***Modification:
Sydney Slipways Marine Maintenance
Facility, Rozelle
(MP05_0187 MOD 3)***

Secretary's
Environmental Assessment Report
Section 75W of the
Environmental Planning and Assessment Act
1979

June 2015

Figure 3: North-east and south-east elevations of proposed light box

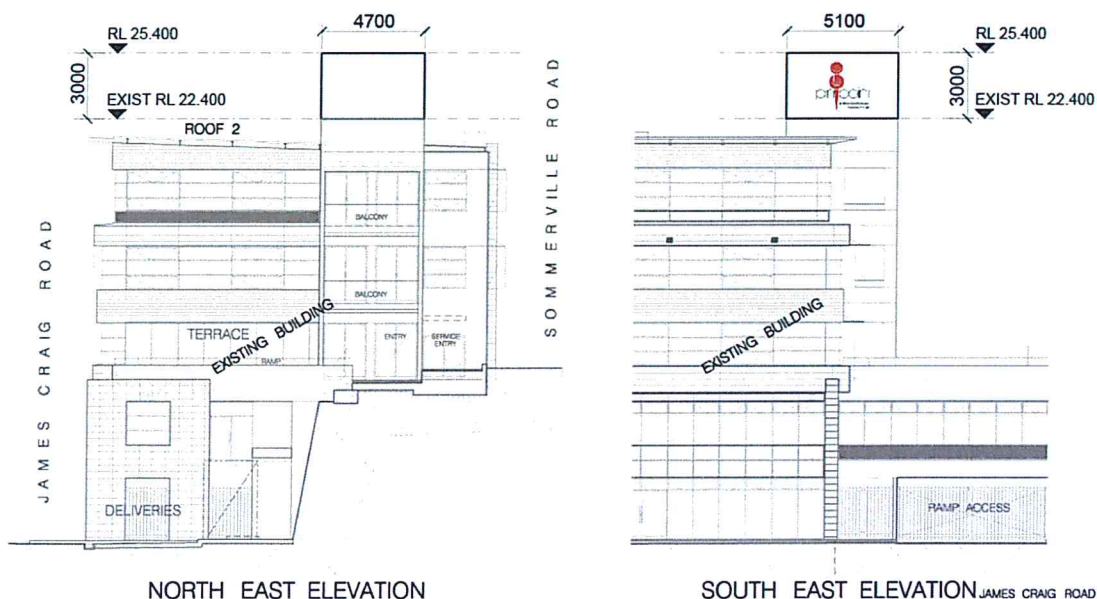
The light box would be installed above the stairwell of the existing building. The proposed light box would be 3 metres high and 4.7 metres wide on the north-east and south-west faces of the building, and 5.1 metres wide on the north-west and south-east faces (**Figure 3**). The proposed light box would consist of aluminium framing and acrylic panels with lighting fixtures inside the light box structure for illumination (until 1am daily). The light box would be used for business identification signage on the south-west and south-east faces and would be leased to the building tenant.

The light box would not present excessive bulk or scale despite the proposed location of the light box on top of the building. The architectural drawings demonstrate that the light box would occupy only 9% of the length of the existing building.

Figure 4: Horizontal view impact from ANZAC Bridge to Sydney Harbour Bridge

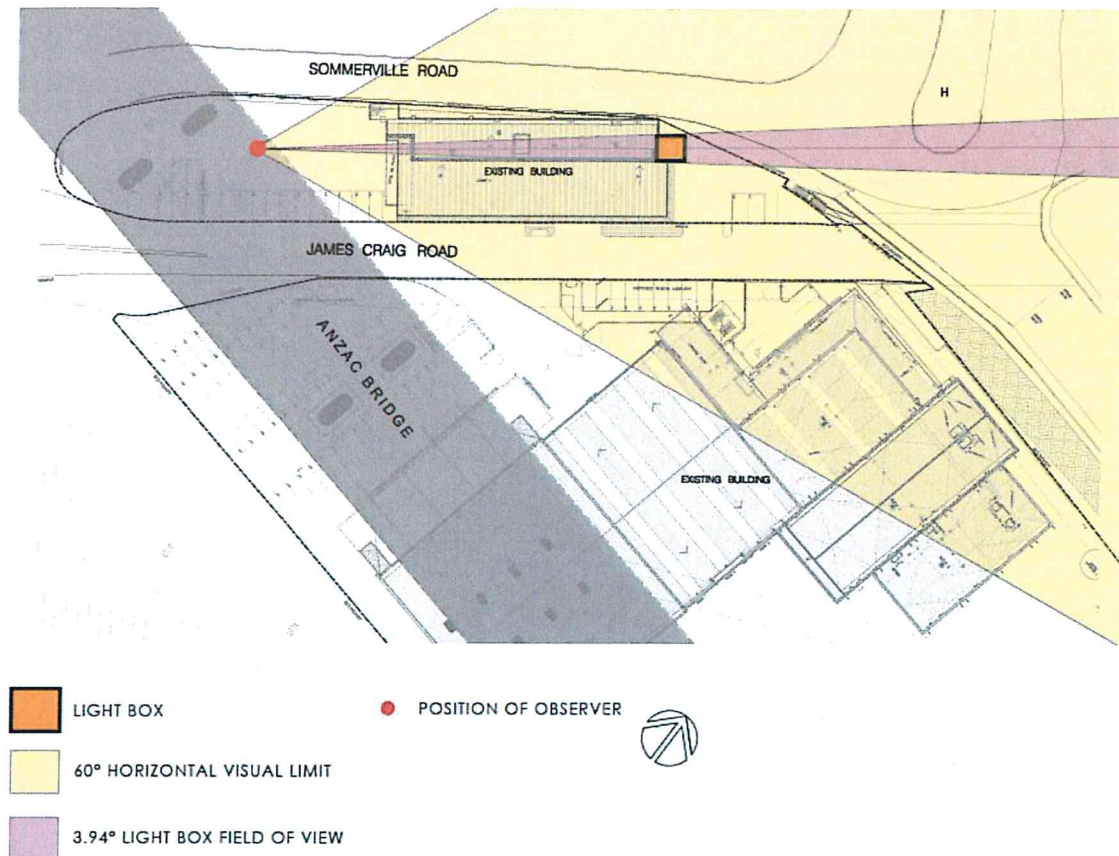
The proposed siting of the light box does not fall within any of the viewpoints or view corridors identified in the Master Plan for Rozelle and Blackwattle Bay Maritime Precincts. However, the DCP states that views from public places to the water and to landmarks should not be obstructed by development. The EA indicates that the proposed light box would obstruct views from the ANZAC Bridge towards the Sydney Harbour Bridge. Based on a 60 degree horizontal view limit, the light box would shield 3.94 degrees (6.66%) of the horizontal view from the closest point of the ANZAC Bridge to the light box, as shown in **Figure 4** (below).

However, the Department notes that the degree of view obstruction by the light box would reduce with distance and that the likely observers from the ANZAC Bridge would be travelling at speed. Therefore, the Department concludes that the light box would not significantly impact on views and vistas between the ANZAC Bridge and Sydney Harbour Bridge.
